Subject: **Review of Transbay Transit Center Design of March 9, 2010**

The Engineering Management Team (EMT) has reviewed the drawing submitted by TJPA's design consultant Parsons Corporation on March 9, 2010. While the team did not conduct a comprehensive review of proposed station configuration and alignment, they were able to focus on three major components of the design:

CAL TRAIN DOWNTOWN EXTENSION
650' RADIUS HSR TRACKS
AND PLATFORM EXTENSION STUDY
FIGURE 2 - TAPERED PLATFORM
MARCH 9, 2010

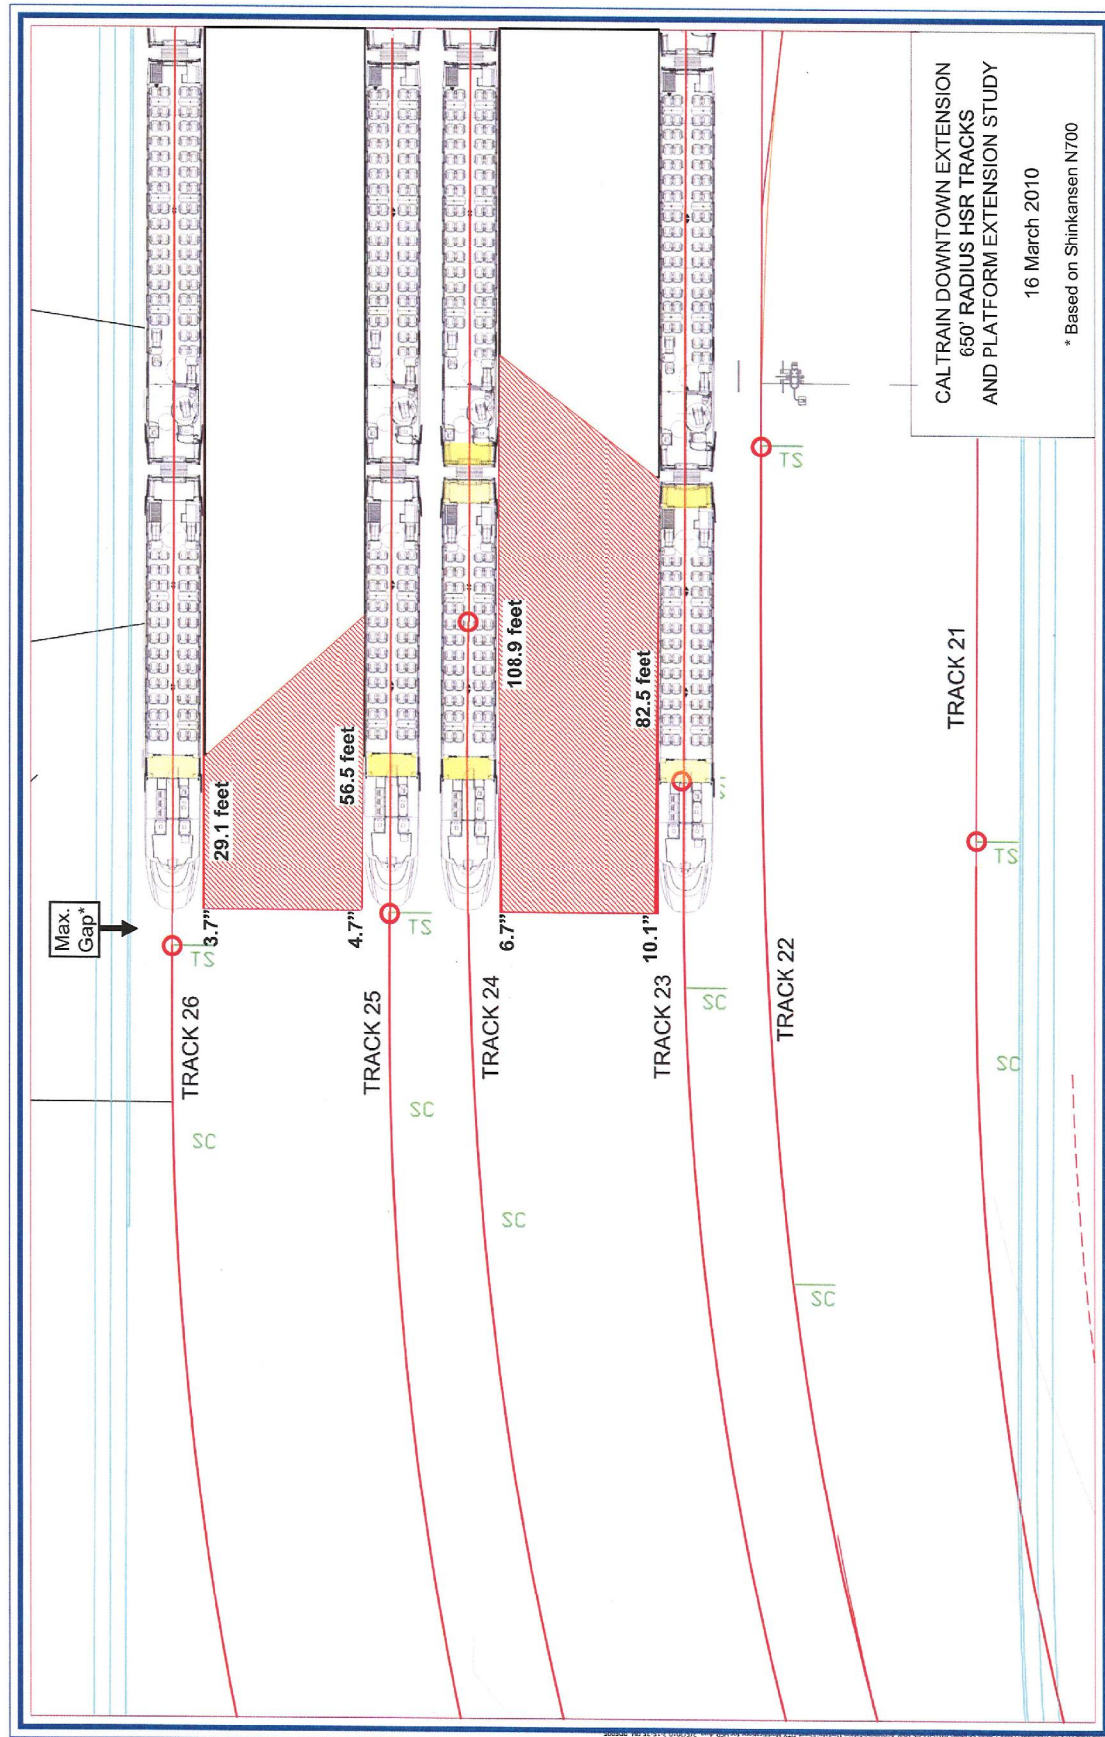
Alignment does not provide length of tangent track (75 foot) either side of platform needed to ensure swing of the cars do not require a tapered platform. In the absence of the tangent, we assessed platform tapers is all that is required. This will also require a design variance.

Platforms on tracks 23, 24, 25 and 26 will all require additional offsets due to the adjacent or proximate curves in the platform tracks. The beginning point of the need for additional car to platform clearance is based on the point at which the swing in the car body begins due to curvature, which is based on vehicle characteristics.

Track 23: 82.5 feet into the platform, maximum offset at end: 10.1 total inches or a 7.1 inch additional gap.

Track 24: 108.9 feet into the platform, maximum offset at end: 6.7 inches or a 3.7 inch additional gap.

Track 25: 56.5 feet into the platform, maximum offset at end: 4.7 inches or a 1.7 inch additional gap.

Track 26: 29.1 feet into the platform, maximum offset at end: 3.7 inches or a 0.7 inch additional gap.

A design variance would be required for the potential platform gap issues.
